Subject: **URGENT MEDICAL DEVICE FIELD SAFETY NOTICE- CORRECTION**

Reference: ZFA2018-00039

Affected Product: Max VPC Tray Base & Max VPC Screw Caddy Brackets

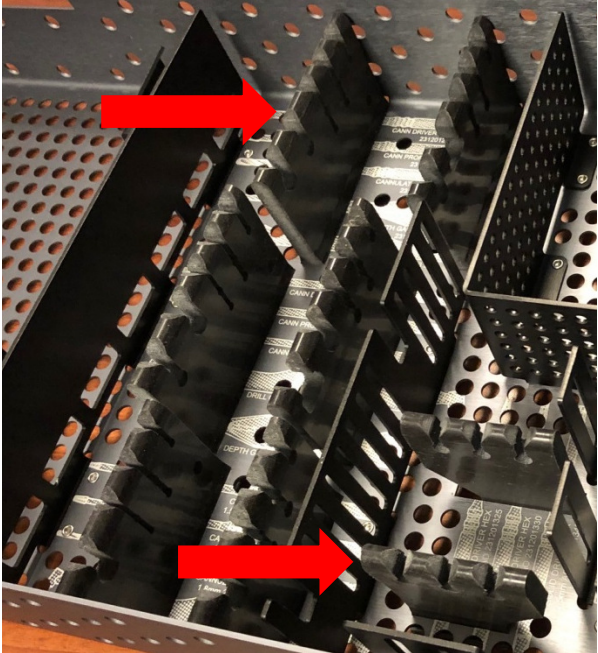
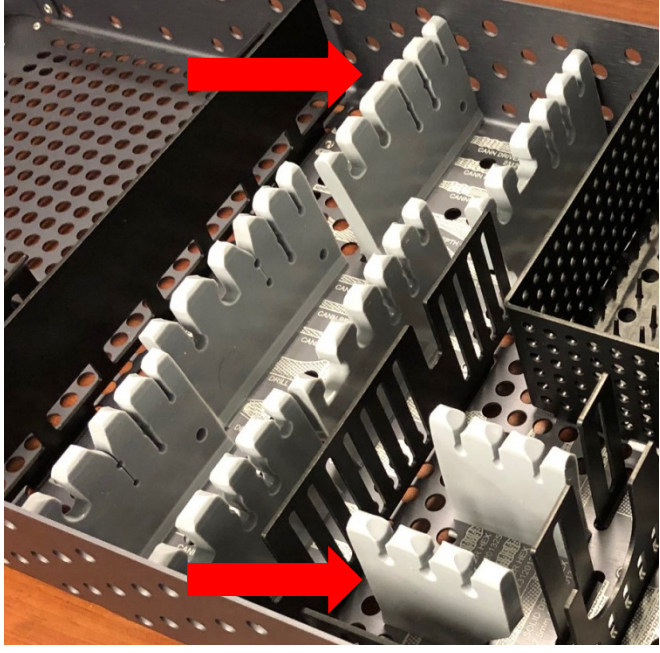
Zimmer Biomet is conducting a lot specific medical device field safety notice/ correction for the Max VPC Tray Base and Max VPC Screw Caddy brackets due to potential silicone shedding during cleaning and sterilization.

This will be a field based correction. A Zimmer Biomet sales representative will retrieve the product from your account. The brackets being corrected are subcomponents of the Max VPC Tray Base and Max VPC screw caddy, and will be replaced with good brackets. Affected units are identifiable by black brackets. Please use the table on page 2 to identify between affected and already replaced brackets.

<p>Affected Brackets (black), please return to Zimmer Biomet Sales Representative</p>	<p>Replaced Brackets (gray), do not return the product, it is conforming.</p>

1. Review this notification and ensure that affected personnel are aware of the contents.
2. If you have affected product at your facility (black brackets), assist your Zimmer Biomet sales representative and quarantine all affected product. Your sales representative will coordinate the replacement of the affected brackets.
3. Complete **Attachment 1 – Certificate of Acknowledgement** and send to fieldaction.emea@zimmerbiomet.com. This form must be returned even if you do not have affected products at your facility.
4. Retain a copy of the acknowledgement form with your records in the event of a compliance audit of your facility's documentation.
5. If you have further questions or concerns after reviewing this notice, please contact your Zimmer Biomet sales representative.
